UNITED STATES PATENT AND TRADEMARK OFFICE

Office Action Summary	Application No. 10/522,502	Applicant(s) ERTLE ET AL.	
	Examiner ROBERT HUBER	Art Unit 4146

DETAILED ACTION

e. Regarding claim 18, **Yoshida discloses a semiconductor chip** (shown in figure 7) **comprising:**

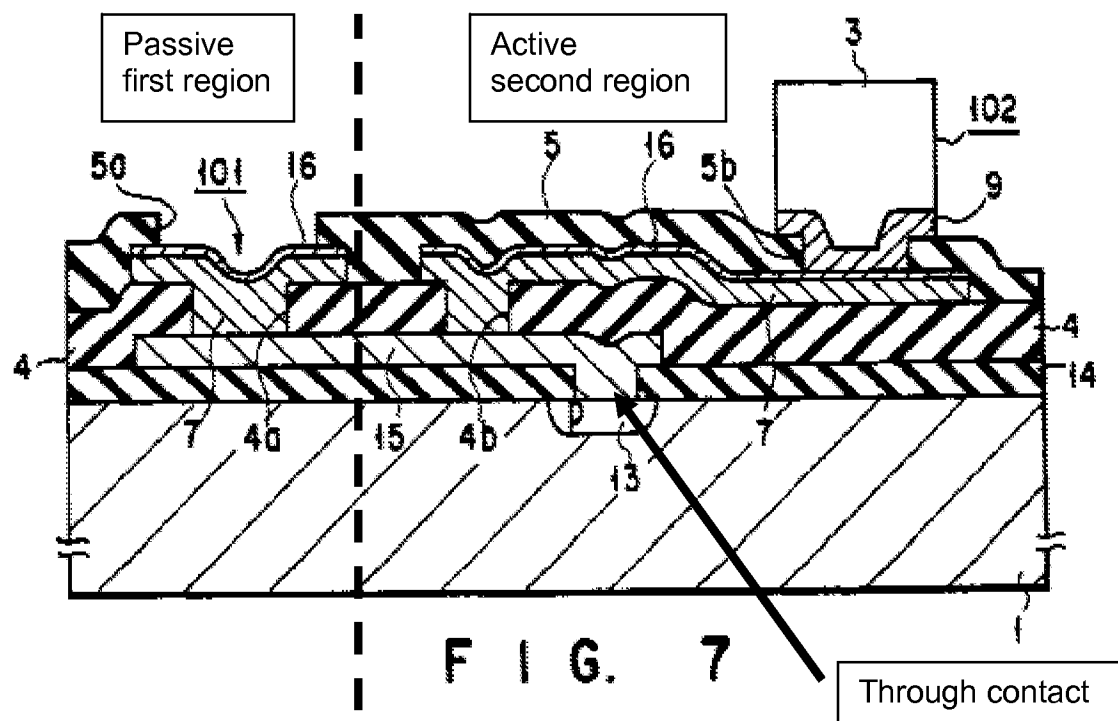
a passive first region on a top side of the semiconductor chip (first region of the chip contain all the components to the left of the number "15". See figure below.);

an active second region on the top side of the semiconductor chip (second region of the chip containing all the components to the right of the number "15". See figure below.);

an arrangement of contact areas and test areas which are in each case electrically conductively connected to one another (contact areas and

test areas comprising the components 7, 16, and 9, which are electrically connected to one another through electrode 15), **the contact areas being arranged in the passive first region** (contact areas 7 and 16 in the passive region), **the passive first region having no components of an integrated circuit** (as seen in figure 7, there are no components of an integrated circuit in the passive region), **the test areas being arranged in the active second region** (test areas 7, 16, and 9 in the active region), **the active second region having components of an integrated circuit** (second region has the active components of a diode, due to the p-type implant 13 and the n-type substrate 1, disclosed in col. 5, line 59).
